FAQ Number 07-0039 FAQ Revision 1

FAQ Title Lessons Learned – NEI 04-02 B-2 and B-3 Tables

Plant: Harris Date: March 28, 2008

**Proposed Markup to NEI 04-02 Section 4.3.2:****4.3.2 Nuclear Safety Performance Criteria Transition Review**

Figure 4-3 - Fire Area by Fire Area Transition Process (Simplified)

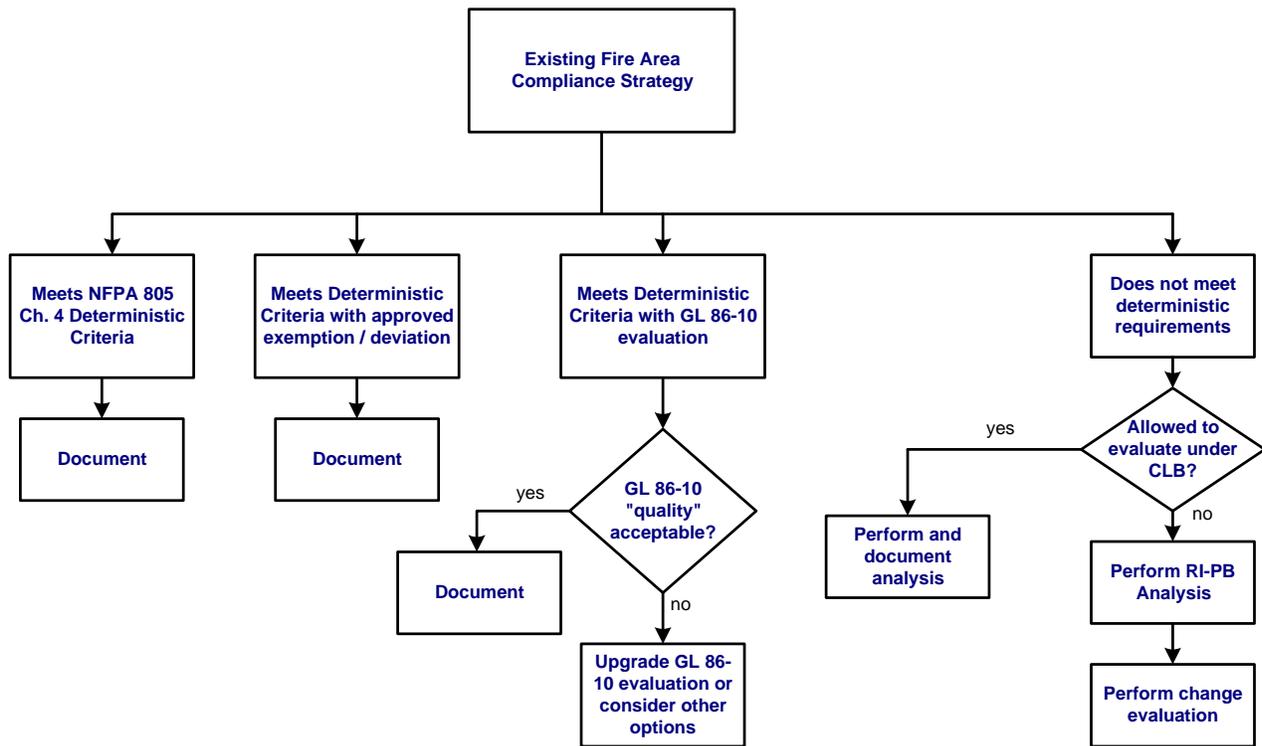
A simplified flowchart of the fire area by fire area transition review is provided as Figure 4-3 below.

The fire area by fire area review determines whether the CLB is intact and documented adequately to support the transition. The review is intended to identify and document how each fire area:

**Figure XX – Summary of Nuclear Safety Methodology Review Process**

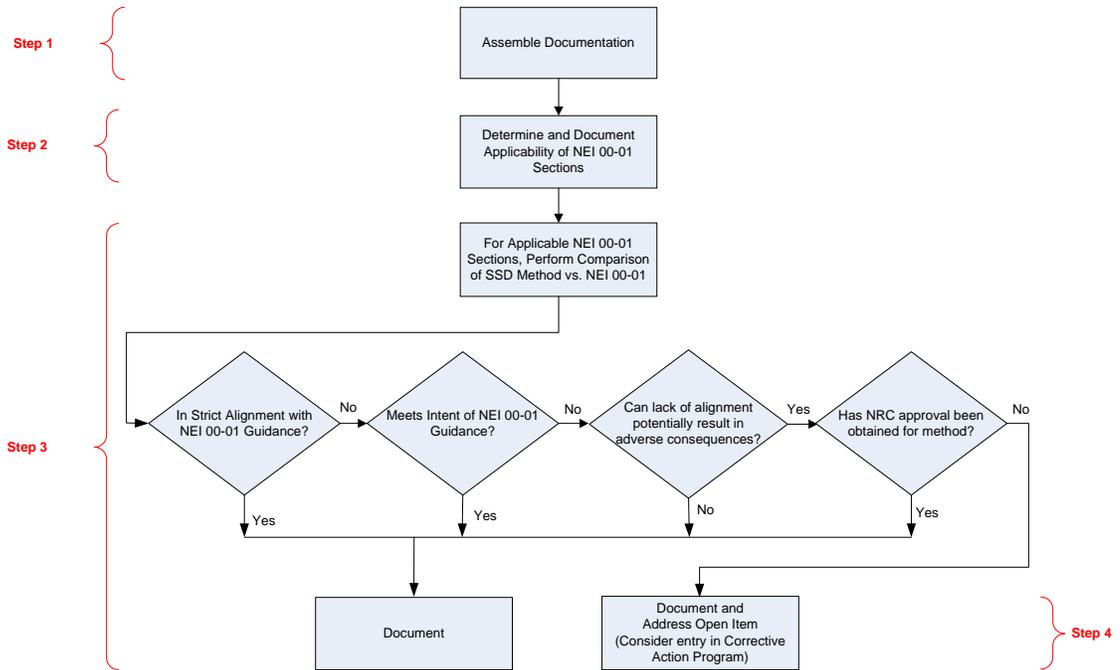
**Suggested Process**

**Step 1 - Assemble Documentation**

**Figure YY – Summary of Fire Area-by-Fire Area Review**

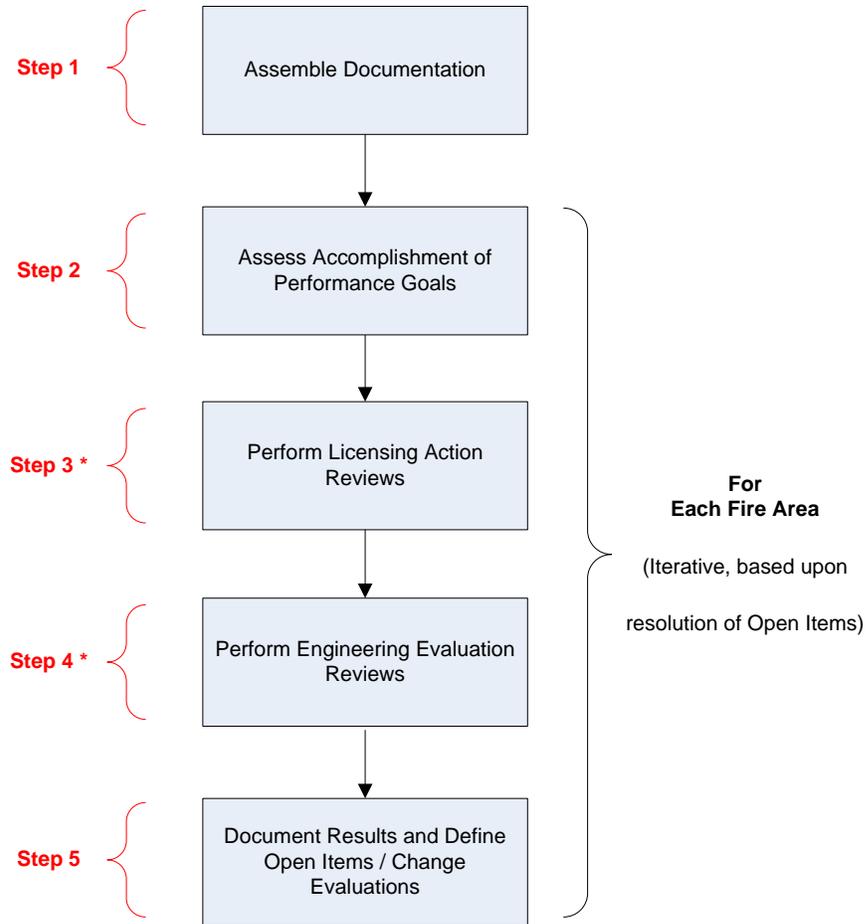
A summary level diagram of the steps to be used in developing the Nuclear Safety Fire Area-by-Fire Area transition review is shown as Figure XX.

\* - These steps may be performed early in the process (e.g., prior to Step 1) for project efficiency, if available resources and program documentation facilitate a review before the performance goal assessment.
